# Access Compliance Report

## Public Rights-of-Way

### (Island Curb Cuts)

Intersection ID: 15766	Main Street: KENILWORTH_AV	Cross Street: PARK_RD	Location:	N/A
ADA ID: 165C6A46D611	Curb Cut Type: IslandRefuge3	Initial Pass/Fail: Fail	Overall Compliance: No	Severity Score: 47.5
Codes/Mitigation Info/Possible Solution		Field Measurements/Component Compliance

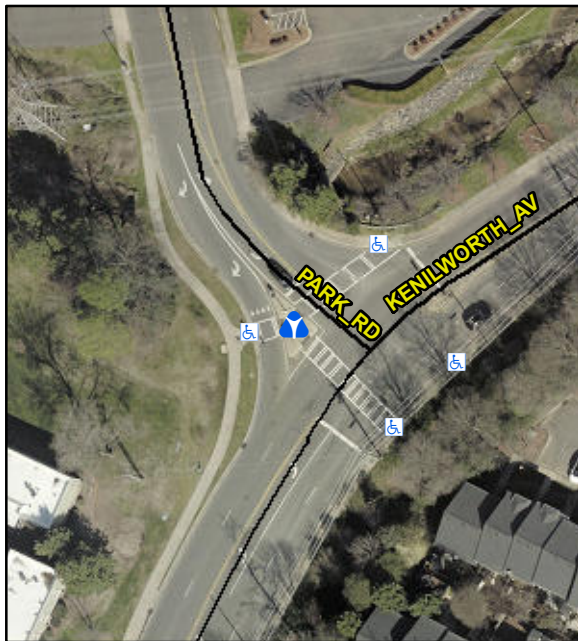
N/A	Road 2 Slope (%)	1.0	N/A	DWS 2 Full Width?	N/A
N/A	Road 2 X Slope (%)	0.2	N/A	DWS 2 Offset (In)	N/A
Yes	Refuge 3 Length (in)	47.0	N/A	Gutter 3 Ponding?	N/A
Yes	Refuge 3 Width (in)	72.0	N/A	Gutter 3 Lip Ht (in)	N/A
No	Refuge 3 Slope (%)	5.8	N/A	Gutter 3 Slope (%)	N/A
Yes	Refuge 3 XSlope (%)	1.4	N/A	Gutter 3 XSlope (%)	N/A
N/A	Painted X Walk3?	Yes	N/A	DWS 3 Provided?	N/A
N/A	X Walk 3 Direction	To SW	N/A	DWS 3 Contrast?	N/A
N/A	X Walk 3 Width (in)	108.0	N/A	DWS 3 Length (in)	N/A
N/A	Road 3 Slope (%)	0.3	N/A	DWS 3 Full Width?	N/A
N/A	Road 3 XSlope (%)	1.5	N/A	DWS 3 Offset (in)	N/A
Yes	Any Obstructions?	N/A	N/A	Storm Grate/Utility Hazard?	N/A
N/A	Obstruction Type		N/A	Storm Grate/Utility Type	
			N/A		N/A
N/A	Surface Condition	Good

**Remove & Replace Entire Refuge.**
